SB-0033

Calculation C-CSS-099.20-054, Revision 0:

Figure 1: Shield building section showing strain, stress, and force distribution under axial and bending demands

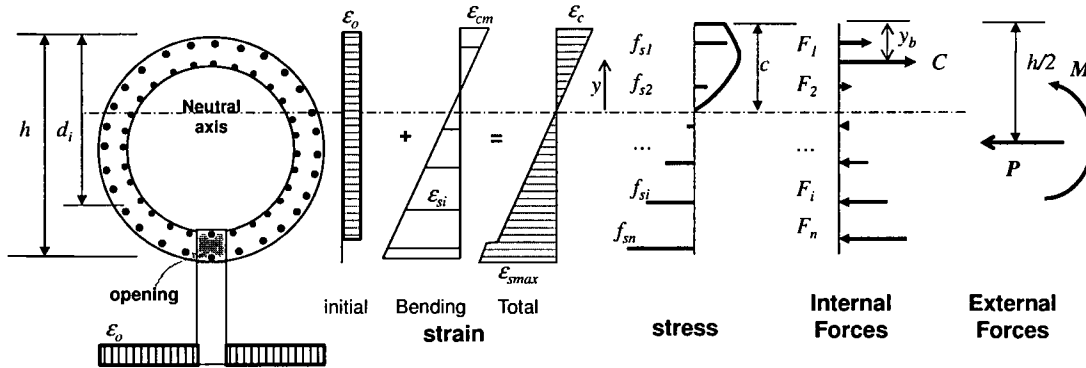
Page 6: The discussion states that “vertical reinforcement next to each flute (i.e. in a vertical strip approximately 10 ft wide) is conservatively ignored for evaluating the structural integrity of the shield building under mechanical loads (i.e., D and E’) as shown in Figure 5 of Attachment B. No rebar is removed for calculation of thermal stresses or crack width under normal operation conditions”. Please explain why the load conditions are treated differently. Also explain why the impact on the horizontal bars (located outside of the vertical rebars and also affected by cracks) is not considered.

- (b) Calculate the maximum compressive (ϵ_c) and tensile (ϵ_{smax}) strains due to mechanical loads (i.e., in the case of interest for D+E') per the procedures presented in Calculation C-CSS-099.20-054 Section 3.2, as shown in Figure 1. Note that similar procedures are presented in ACI 307-69 supplement figure 18 and its accompanying equations.
